January 28, 2022

Re: Avista's Clean Energy Plan (CEIP) pursuant to WAC 480-100-640 Docket No. UE-210628, Comments of Sierra Club

Figure 1: Avista v. NREL On-System Wind Costs

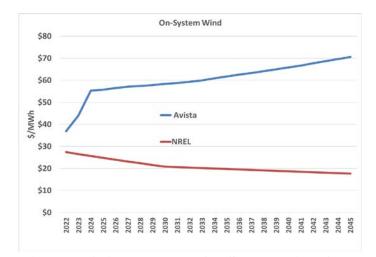
In the 2021 IRP analysis that forms the basis for the CEIP, Avista's assumptions¹ for the cost of renewable and storage resources were extremely high relative to other widely used resources. The utility's analysis prejudices Avista's resource selection away from renewable resources and towards other resources such as gas generators. As shown in the charts below, Avista's assumed costs for wind and solar are roughly twice as high as the costs reported in the National Renewable Energy Laboratory ("NREL") Annual Technology Baseline, and Avista's assumed battery storage costs are also significantly higher than NREL's. The first four charts compare Avista's assumed levelized costs for wind² and solar³ against comparable resources classes in NREL's dataset. The final chart shows how Avista's assumed capital costs for batteries compare to those from NREL. Avista's wind and solar cost assumptions included the benefit of federal tax credits during the first few years of the analysis, while tax credits are not accounted for in the NREL levelized costs shown below. As a result, the discrepancy between the Avista and NREL assumptions during the first few years is even *larger* than is depicted in these charts.

In part, Avista's costs are much higher than NREL's because Avista's 2021 IRP used wind and solar cost figures from a 2019 report from investment firm Lazard.⁴ However, Lazard's 2021 update to that report showed large continued cost declines over the last two years.⁵ Avista's estimated capacity factors for wind and solar resources are also low relative to those in NREL's Annual Technology Baseline.

Avista added approximately \$5/MWh to wind and \$1.80/MWh to solar costs to account for claimed costs of integrating those variable resources.⁶ The charts above show Avista's assumed wind and solar PPA costs before integration costs are added, while the solar costs shown in the charts include Avista's \$1.80/MWh integration cost. This means that the discrepancy between the Avista and NREL wind costs is even larger than it appears in the charts.

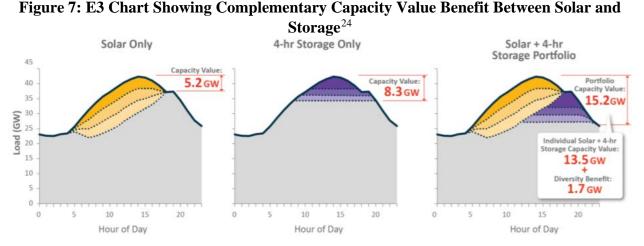
These synergistic benefits among wind, solar, and storage occur because wind and solar have negatively correlated output profiles, and because solar and wind complement storage by shortening the duration of peak net load periods (as illustrated in the example below for a hypothetical power system). As a result, portfolios of wind, solar, and storage resources provide a capacity value that is greater than the sum of the capacity values of their component parts.

Figure 8: Peak Load Reduction by Aggregating Across US Portion of NWPP

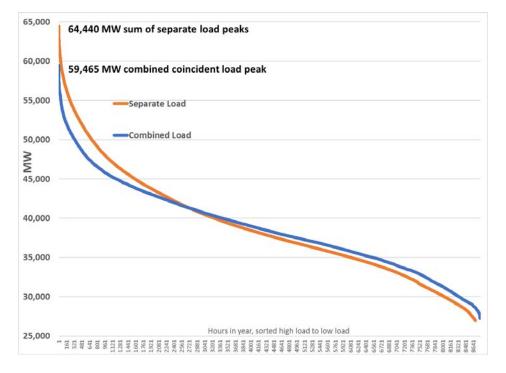
We conducted independent analysis that verified that the NWPP region is likely to see larger benefits than Avista assumed. By comparing stand-alone versus regionally aggregated Energy Information Administration hourly load and generation data for grid operators in the U.S. portion of the NWPP,³⁰ we found a large reduction in peak capacity needs from aggregating diverse loads and renewable resources across the region. Even in 2020's worst case scenario of a heat wave across much of the West, there were still significant geographic diversity benefits across the region. As shown in the load and net load duration curves below, the U.S. portion of the Northwest Power Pool could have realized a 5 GW reduction in peak load and 7 GW reduction in peak net load (from 2 GW of renewable diversity benefit) in 2020 if it aggregated diverse loads and renewable resources by evaluating resource adequacy on a regional basis. The 7 GW reduction in peak net load reduces the need for capacity by 11%, much larger than Avista's estimate, and translates into regional savings of around \$5 billion if the benefit were realized through a reduced need for new gas combustion turbine capacity.³¹ Preliminary NWPP analysis confirms the resource adequacy program can drive large reductions in reserve margin needs.³²
